# **Radiation Safety Engineering Assessment Report for the Rapiscan Secure 1000 in Single Pose Configuration**

**VERSION 2.0**

**NSTD-09-1085**

## **Radiation Safety Engineering Assessment Report for the Rapiscan Secure 1000 in Single Pose Configuration**

Figure 8-4. Filtered Exposure Readings and HVL

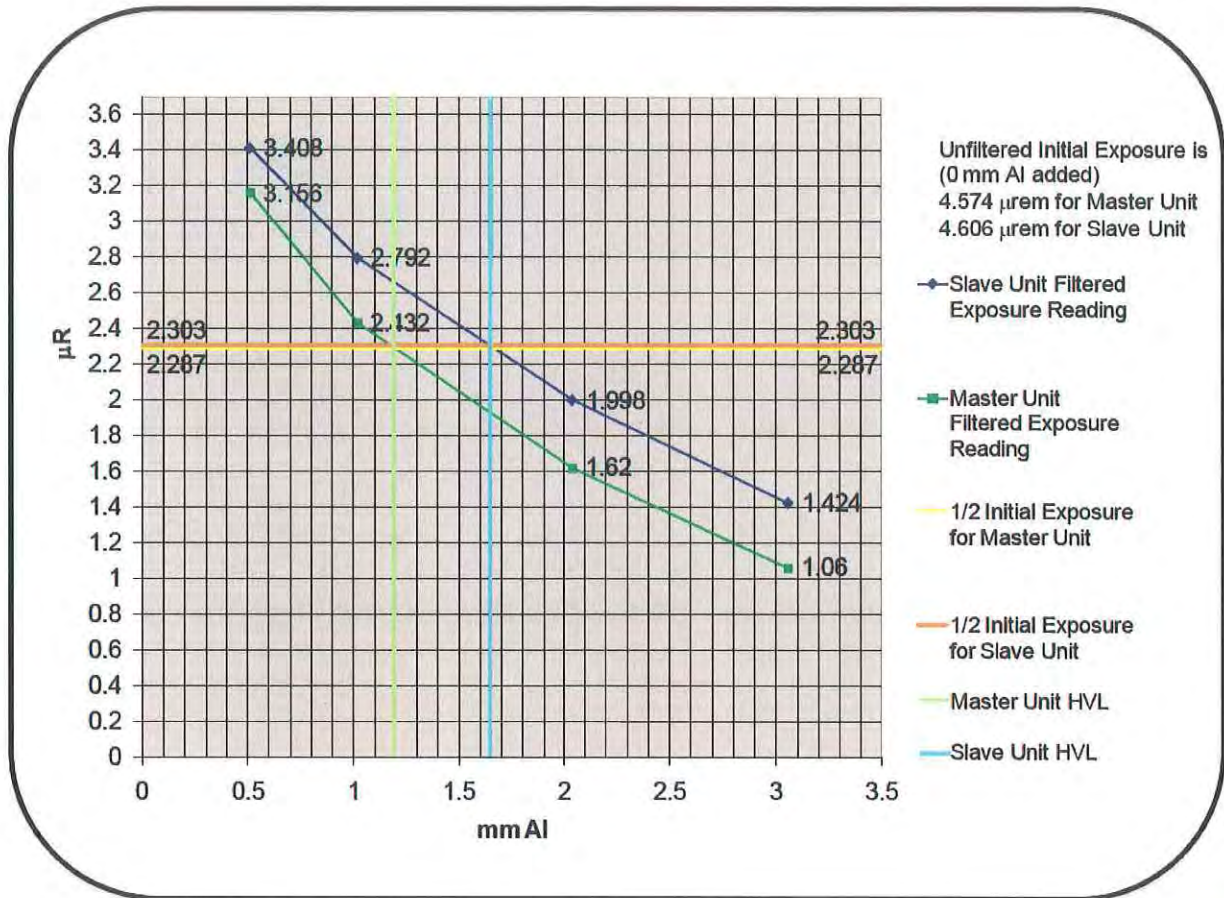
Section 8.3, Figure 8-4	As a result of a typographical error, the following text in the legend was changed in Figure 8-4: "4.71" changed to "4.574" $\mu\text{rem}$ for Master Unit "4.68" changed to "4.606" $\mu\text{rem}$ for Slave Unit
Section 8.3, Table 8-3	As a result of a transcription error in Tables 8-3 and 8-4, where background exposure was corrected from 0.0006 $\mu\text{R}$ to 0.06 $\mu\text{R}$ , the following changes were made in Table 8-3 to reflect this correction:

Figure 8-11. Dose to General Public Above Units

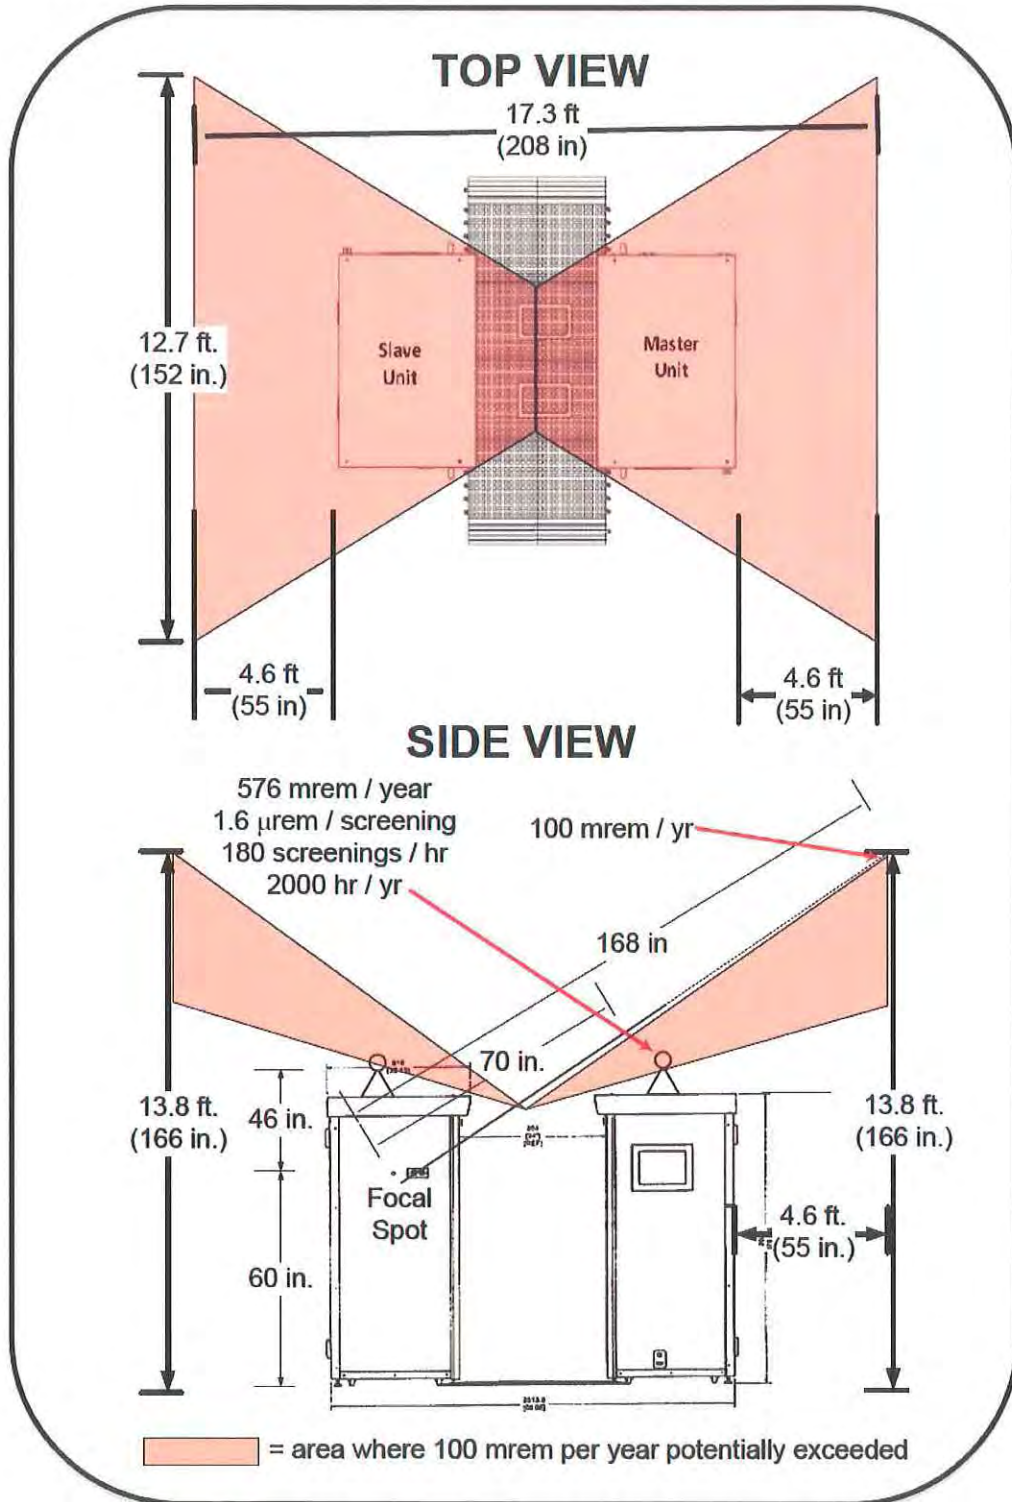
- An area exists above each of the units, due to primary beam overshoot, where the 100 mrem per year general public dose limit could potentially be exceeded. This area extends up to a height of about 14 ft and 4.6 ft behind each of the units.

Based on the data collected during the area survey as described in Section 8.6.1, dose to the general public was determined. An area above the units could potentially exceed the 100 mrem per year general public dose limit, as shown in Figure 8-11. This area extends to a height of approximately 14 feet from the ground and approximately 4.6 feet behind the units. Using the maximum dose of 1.6  $\mu\text{rem}/\text{screening}$  (reference Table 8-7) at a location above the slave unit and using approximate geometric measurements of the X-ray beam path the distance at which the general public dose limit of 100 mrem/year was determined. These measurements assume 180 screenings per hour (30% duty cycle) and 100% occupancy for 2000 hours. It should be noted that this is a conservative assumption based on the maximum dose of 1.6  $\mu\text{rem}/\text{screening}$ . As discussed in Section 8.6.1, the dose per screening above the slave unit was found to be dependent on the vertical motion of the X-ray generator. Doses are higher when the X-ray generator [REDACTED] as shown in Table 8-7 and 8-8. 5 USC 552(b)(4)

- It is recommended that a survey of each installation site be conducted to ensure that the dose to any member of the general public is maintained below the 100 mrem (0.1 rem) per year general public limit and to ensure that doses are kept “As Low As Reasonably Achievable” (ALARA).

- For the area above the units, a beam stop may be considered to ensure the general public dose is maintained.
- The dose to bystanders is within the requirements of ANSI/HPS N43.17-2002, 5.4 and ANSI/HPS N43.17-2009, 6.2:

**Figure 8-12. Dose to General Public at Entry and Exit Locations**

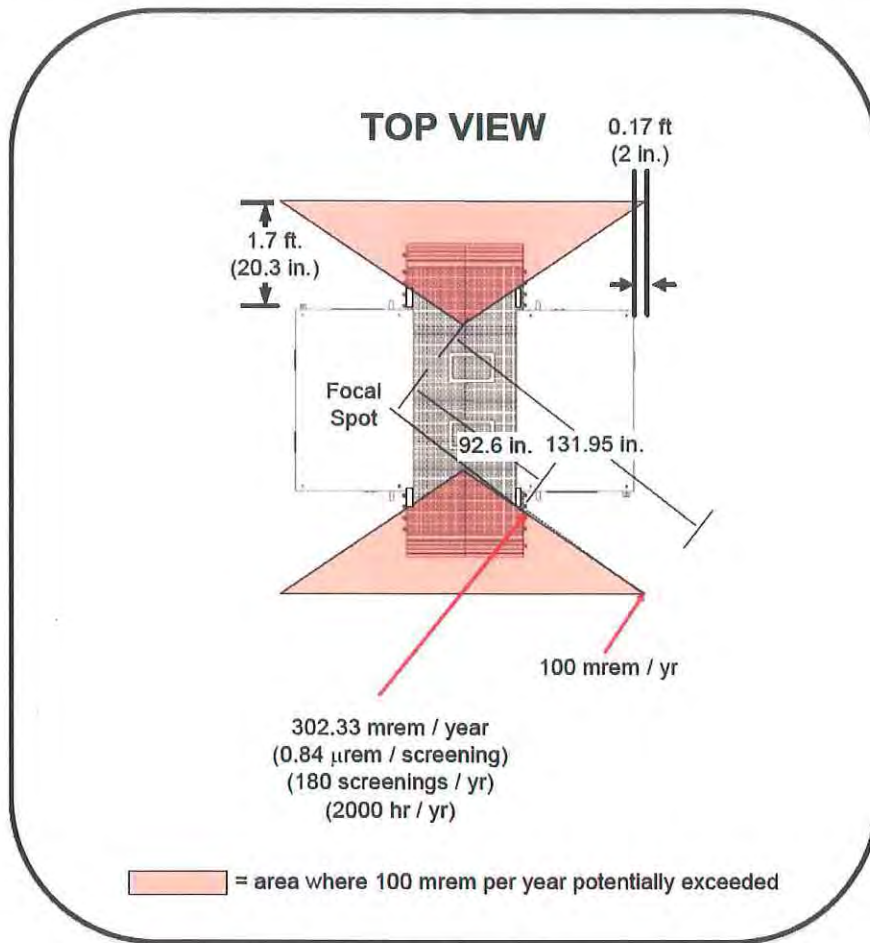
- A second area exists at the entry and exit locations of the scan area, where the 100 mrem per year general public dose limit could potentially be exceeded. This area extends approximately 1.7 ft from the side of the units at the entry and exit locations.

Using the maximum average dose measurements from the wing locations, an area that extends 1.7 feet from the sides of the units at the entry and exit locations could potentially exceed the 100 mrem per year general public dose limit, as shown in Figure 8-12. Using the maximum average dose measurement of 0.84  $\mu\text{rem}/\text{screening}$  and approximate geometric measurements of the X-ray beam path, an approximate 100 mrem/year area was determined. These measurements assume 180 screenings per hour (30% duty cycle) and 100% occupancy for 2000 hours.
